1 SITE SKETCH
 SKC-1 SCALE: 1" = 60'-0"

JOB TITLE: VAMC WILKES-BARRE WAREHOUSE RENOVATION PROJECT NUMBER: 693-12-055	DRAWING TITLE: CIVIL SKETCH 1	DATE: 08/07/17 PAGE SIZE: 8-1/2"x11" JOB NUMBER: 693-12-055	DRAWING BY: D. PFEFFER SKETCH NUMBER: SKC-1
---	---	---	--

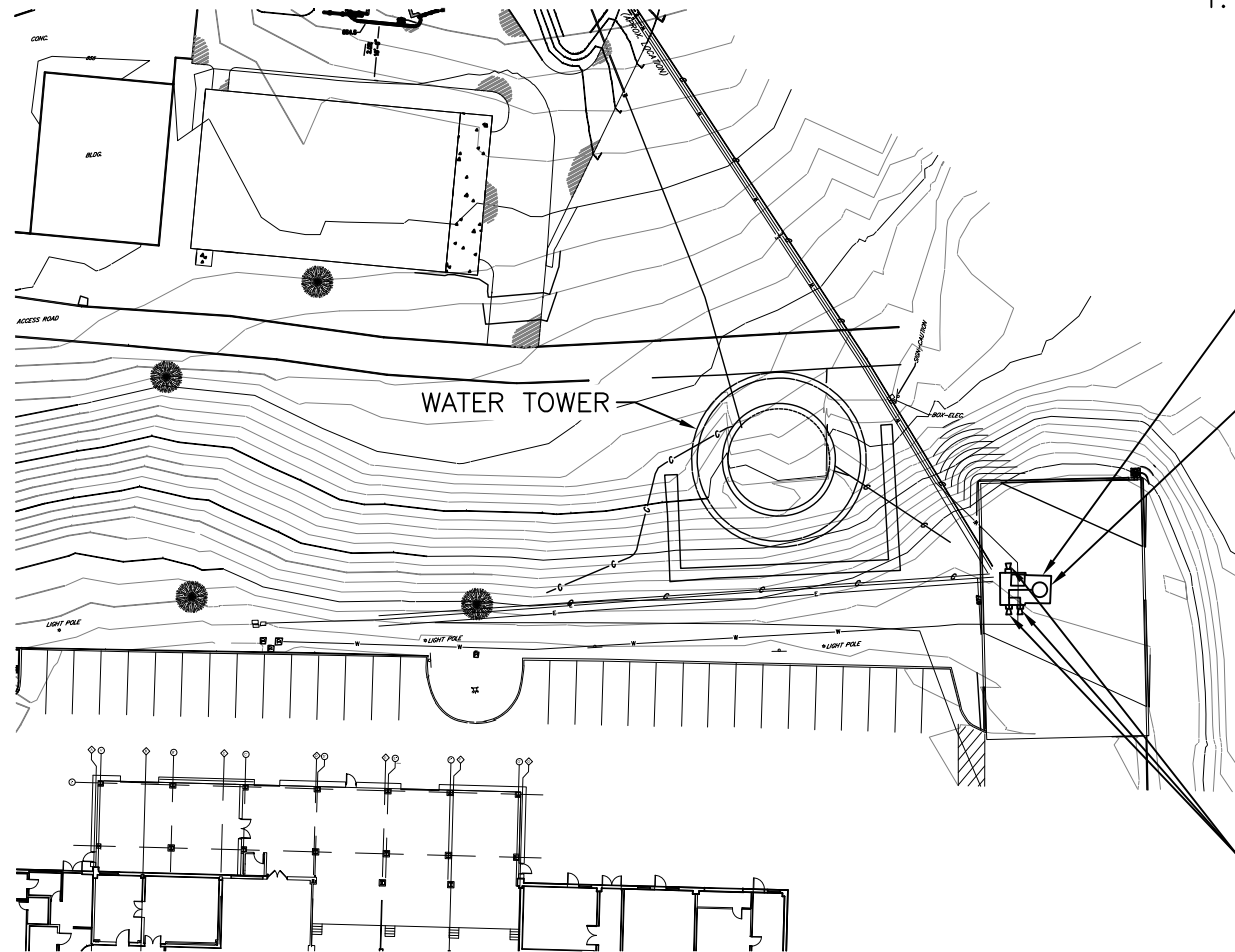
VALVE CHAMBER TO BE CUT AND REMOVED TO 3' BELOW GRADE. PUNCTURE CHAMBER FLOOR TO PROMOTE DRAINAGE AND BACKFILL CHAMBER WITH CLEAN STONE. ALL PIPING AND APPURTENANCES CONTAINED WITHIN TO BE ABANDONED IN PLACE (SEE NOTE 1)

VALVE CHAMBER PIPING TO BE CUT AND CAPPED OUTSIDE OF VAULT WALL (TYP.)

1. CONTRACTOR TO COORDINATE WITH VAMC PROJECT NUMBER: WBVAMC-693-13-109, PROJECT NAMED: UPGRADE FIRE PROTECTION PIPING AND LOOP. REMOVAL OF MANHOLE NOT TO BE INITIATED UNTIL MENTIONED PROJECT IS COMPLETED.
